## MEMORANDUM

TO FILE: American Nuclear Corp., Permit 357  
 FROM: Jim Finley, Hydrologist  
 DATE: October 29, 1985  
 SUBJECT: Review of Groundwater Conditions and  
 at the American Nuclear Mill Site

Figure 1

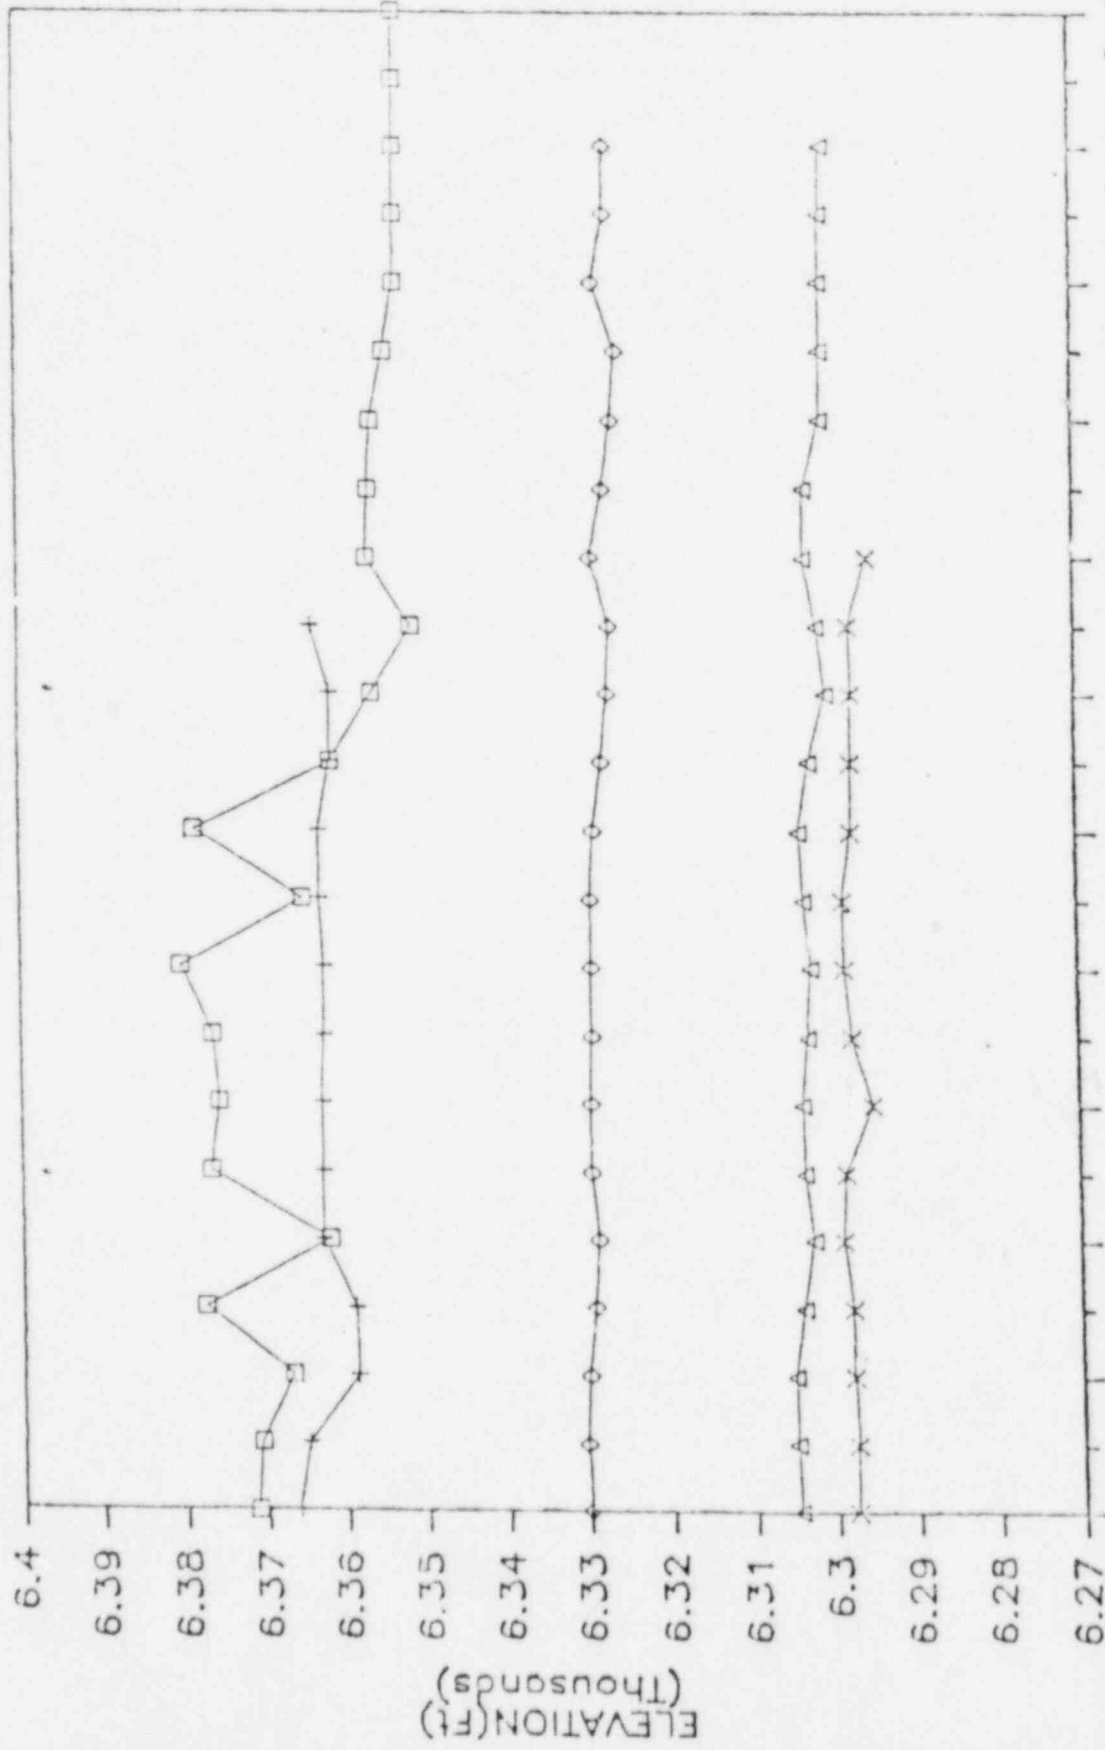
A new review of the data contained in the report was conducted in which both water levels and water quality were analyzed. Water levels for several monitoring wells were plotted against time. Water levels from five wells indicate that the pumpback system has not historically had much of an affect on the flow gradient (Figure 1). With no baseline or pre-1979 data, it is not possible to determine whether or not these down gradient water levels reflect the influence of seepage. Some of the original mathematical modeling of the perched aquifer indicates that water from this aquifer discharges approximately 2000 feet north of the tailings pond. The piezometric map and Figure 1 suggest this is not true, but that a discharge area possibly exists to the north of the Fox wells. Water levels are below the topographic surface in the three Fox wells plotted on Figure 1.

Figure 2

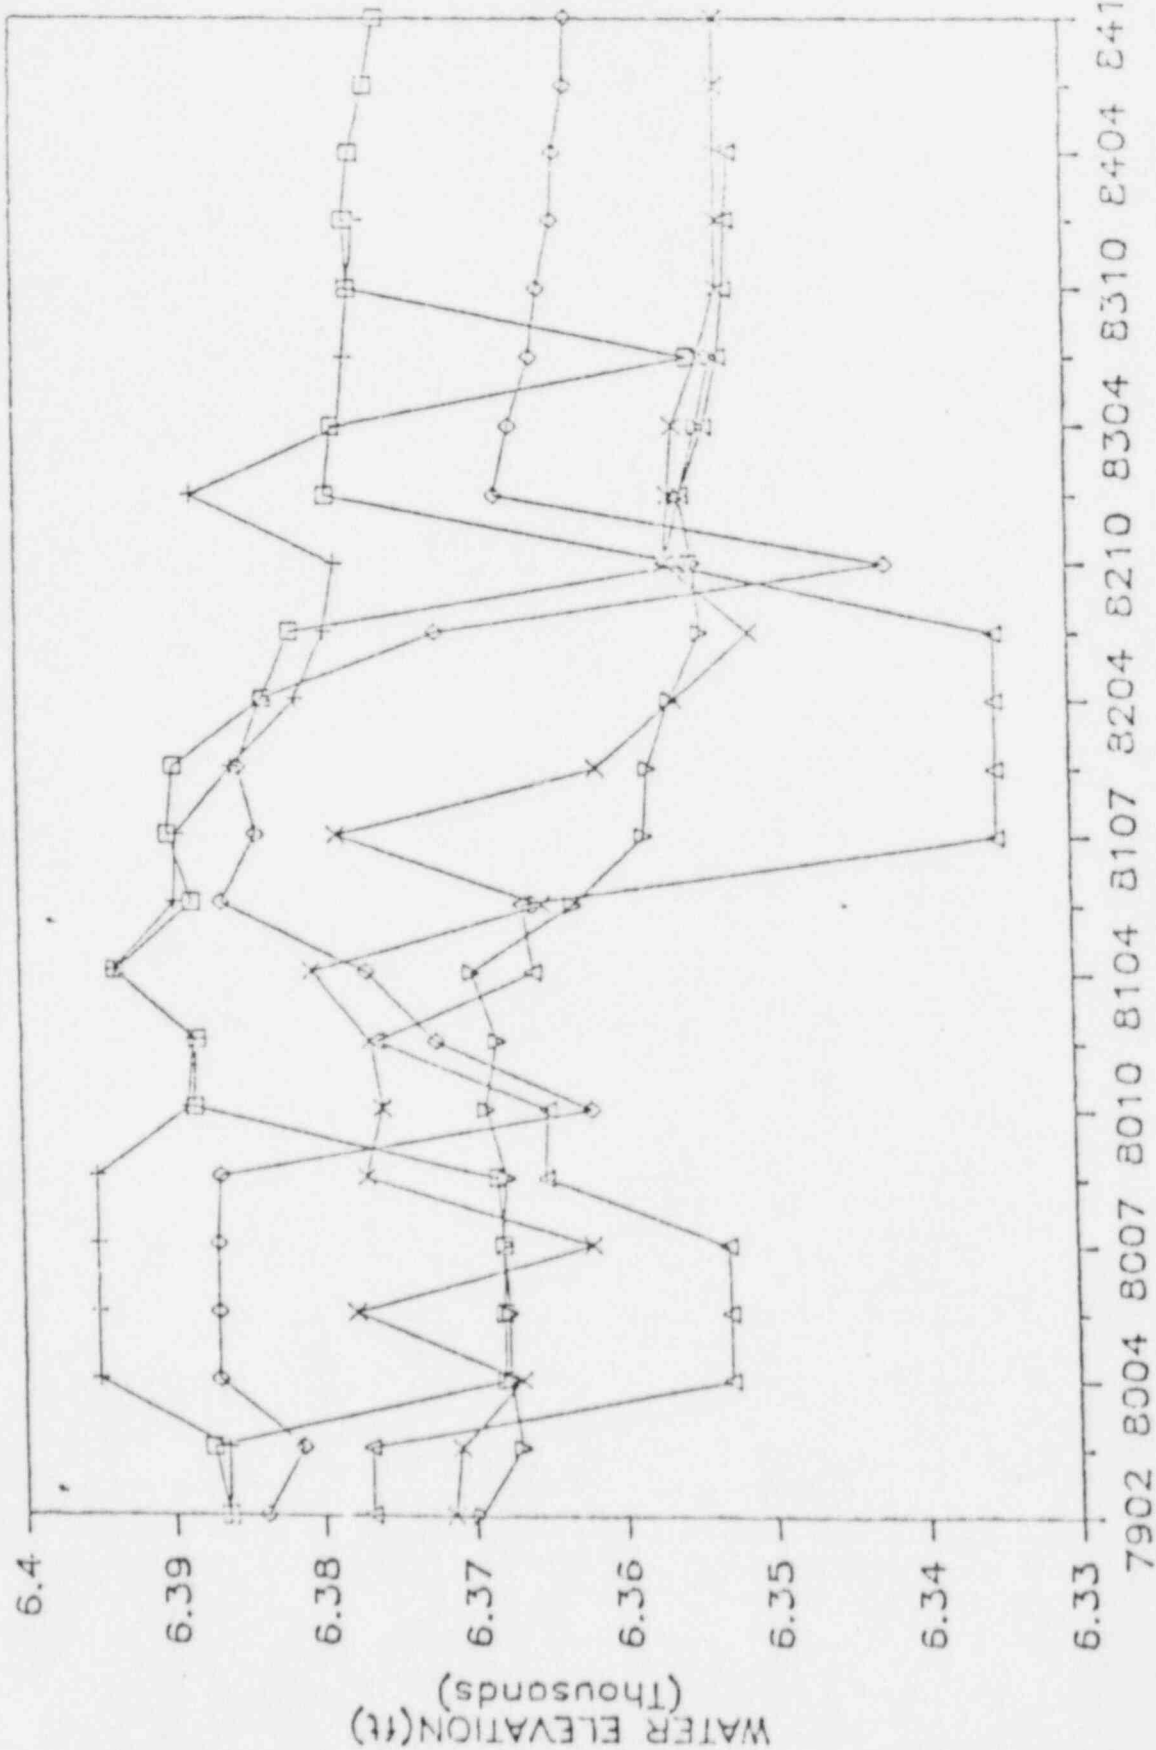
Periods of active pumping from the recovery wells have been sporadic for all wells (Figure 2). Water levels in the recovery wells have decreased since 1979, which is a combination of pumping and decreased water levels in Tailings Pond 1. R-4 has been pumped the most actively though water remains in all wells but R-5. This is not surprising considering that these wells should be drilled to the top of the clay and pre-mining water levels existed in the perched aquifer. Through time, decreased water levels in these wells should become stable, at which point seepage from the tailings pond will have ceased.

An effective pumpback system is necessary in order to minimize further seepage movement into the perched aquifer. The well system has not worked very reliably to date (Figure 2; see August 6, 1985 memo Niles Andrus to NRC). A rejuvenation of the well system coupled with a more effective evaporative technique (e.g. a mist system) should be considered for any decommissioning of this tailings pond.

1. Renovation/upgrading of the pumpback system below Tailings Pond No. 1. This is imperative if the Susquehanna tailings are disposed of at this site.
2. Construction of a lined evaporation pond outfitted with equipment to enhance evaporation. Pumpback well operation is suggested during the summer months.

Figure 3

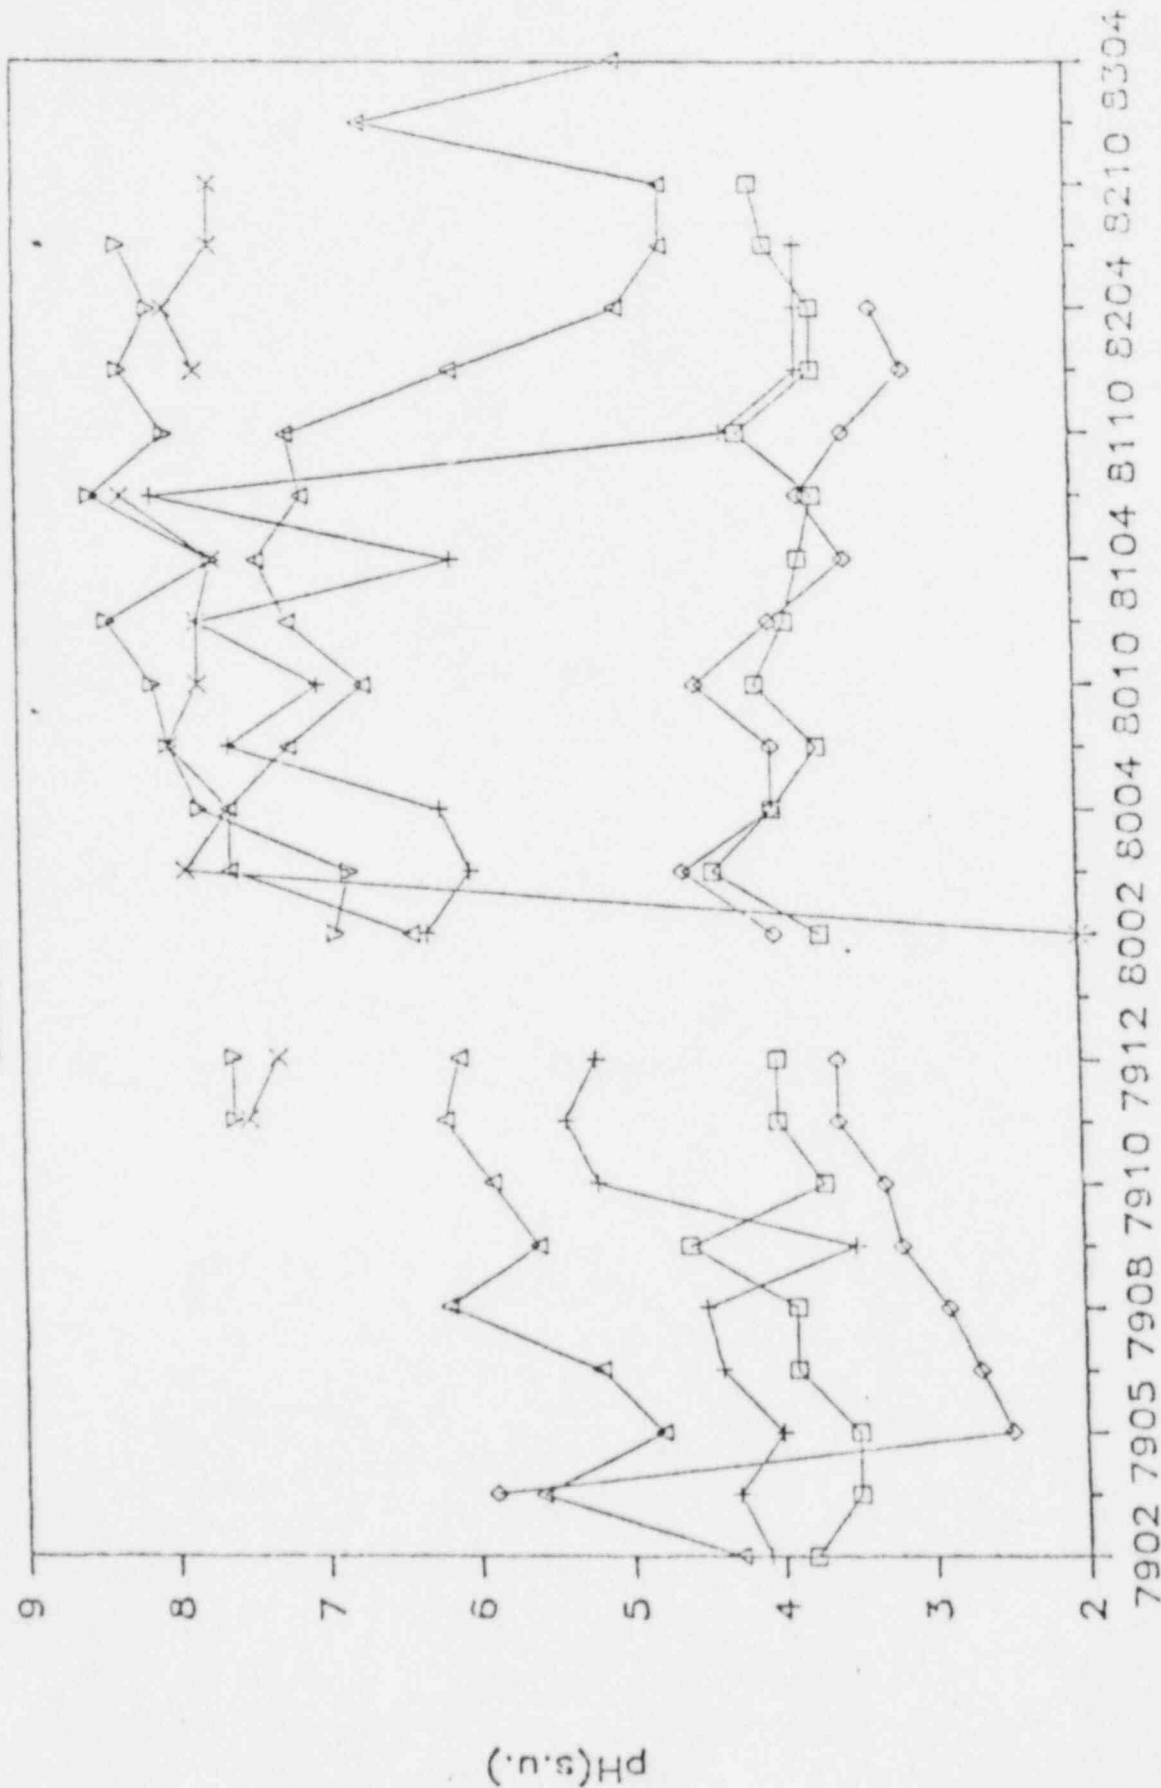
Several water quality parameters were plotted against time for wells in a down gradient direction (Figures 3, 4, 5, and 6). Values of pH rise from two (tailings liquor) to eight as distance down gradient of the tailings is increased (Figure 3). Low pH fluids seeping from the tailings pond are buffered by the natural salt content of the perched aquifer. The rate at which the buffering occurs is controlled by two processes: (1) reaction kinetics; (2) and relative permeability of the aquifer. Reaction kinetics is fixed if the medium is homogeneous. Directional permeability will control rates of flow affecting contact time. Zones of increased permeability (e.g. sand or gravel lenses) will transport low pH water further from the tailings pond. Changes in pH and Eh regulate the relative solubility of major cations and anions, and indirectly the chemistry of toxic trace elements (Johnson, 1985). Values of pH below 6 occur as far down gradient as TP1-1 (Figure 3). It is expected that the zone of low pH will slowly increase in size as the buffering capacity of the aquifer material is exhausted.

Figure 4

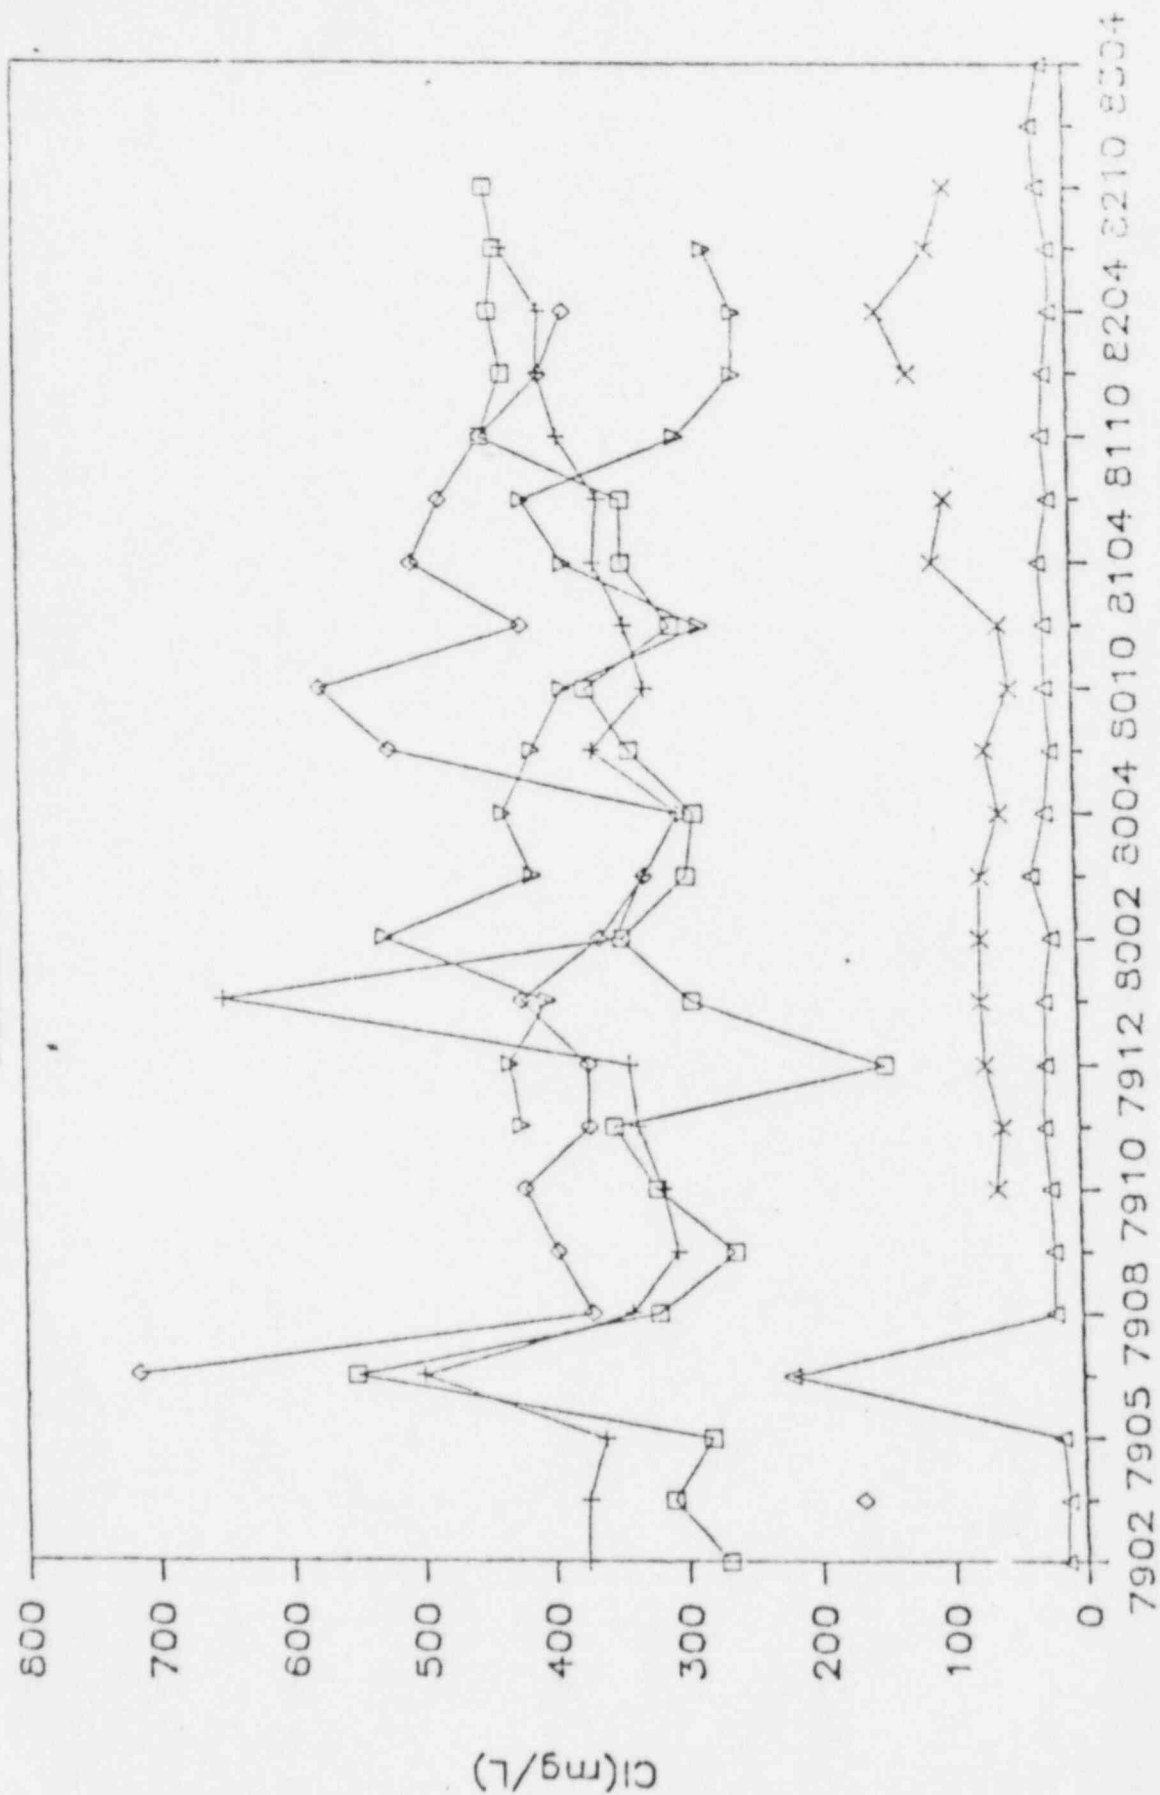
Chloride concentrations show no increasing or decreasing trend for any wells through time (Figure 4). Values range between 250 and 575 mg/L for all wells but Fox 2 and TP1-1. This again suggests that the sampling conducted to date reflects not pre-seepage conditions but those already created as a result of seepage. Other constituents plotted reflect the same conditions (Figures 4, 5, and 6). Nitrates at three wells peak in late 1981 then drop to within 10 and 20 mg/L (Figure 5). Sulfates generally increase in a down gradient direction with very high values recorded at Fox 5. Four wells range between 2000 and 7000 mg/L with a rising trend from 1981 to late 1982 (Figure 6). In all cases, Well TP1-1 had the lowest concentration of all parameters which indicates the plume has not moved in this direction. Flow may move in a more westerly direction though data are not available to evaluate this possibility.
